COMAL COUNTY

License to Operate On-Site Sewage Treatment and Disposal Facility

Issued This Date: 10/17/2019 Permit Number: 108542

**Comal County Environmental Health
OSSF Inspection Sheet**

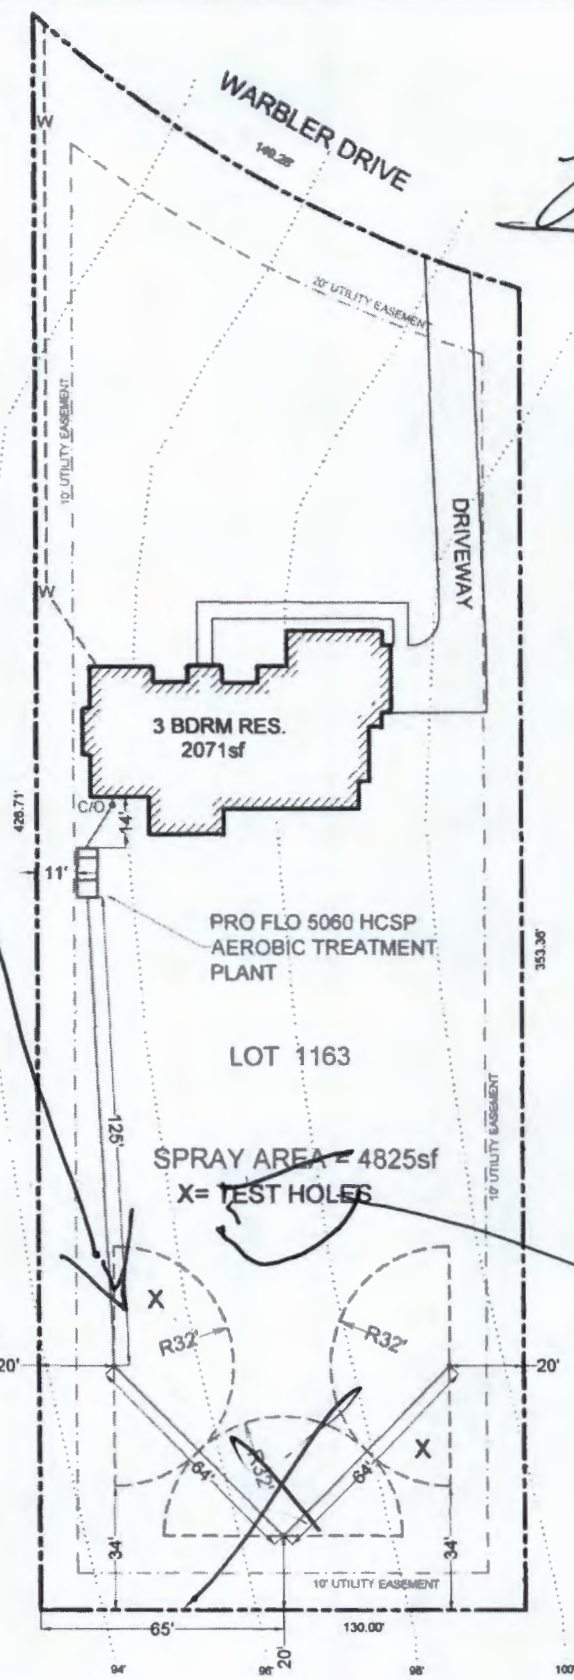
revision needed for spray head layout

*Cover
with
spray area*

*Remove
trees
< 10'
Cover with
spray area
Report for
K-10*

REVISED
8:35 am, Jun 03, 2019

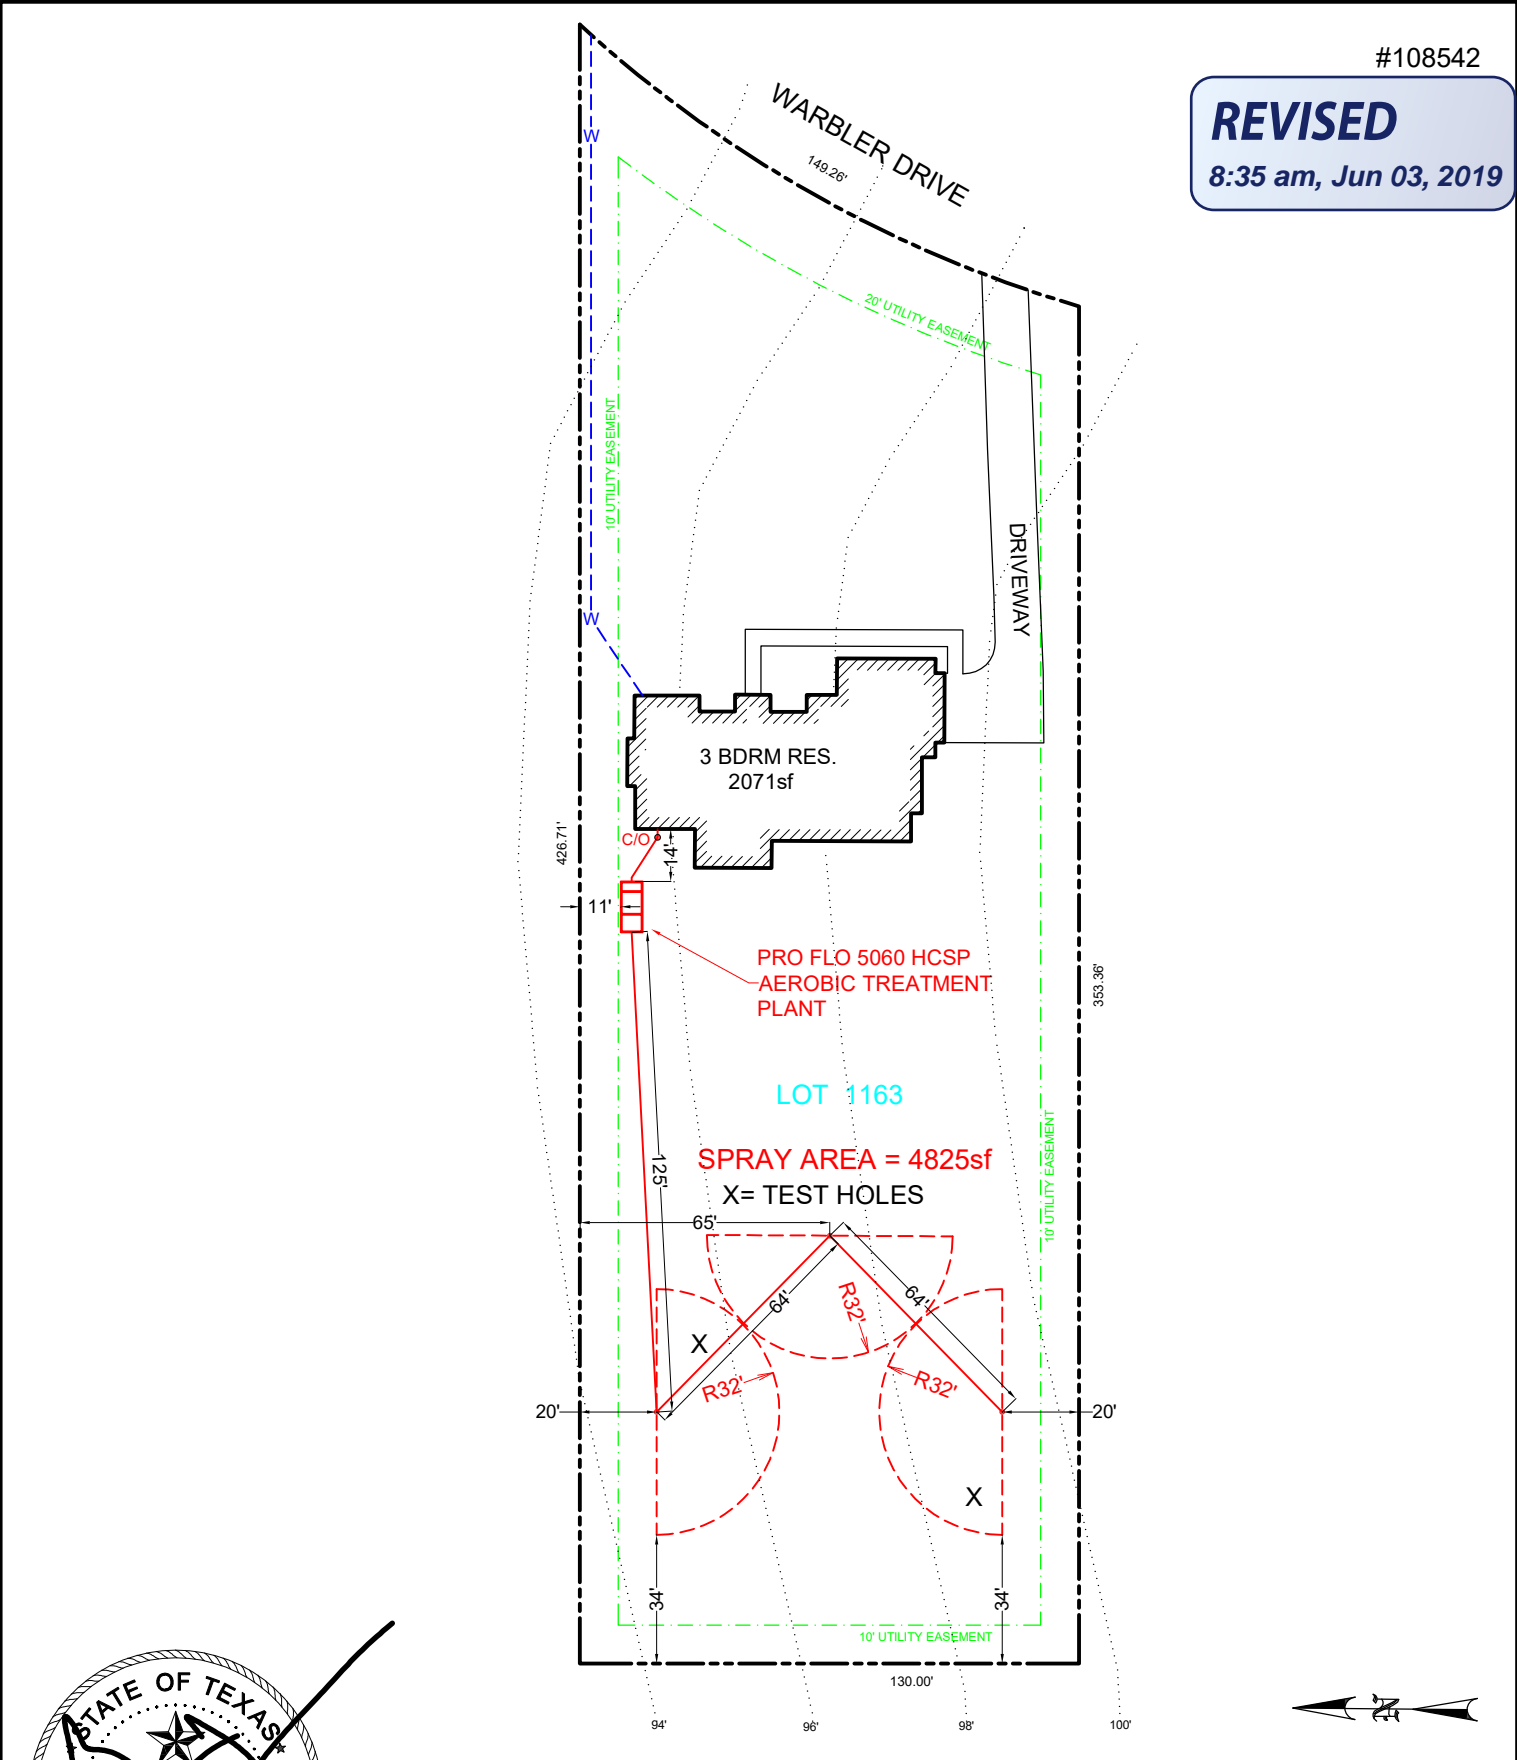
revision needed for spray head layout
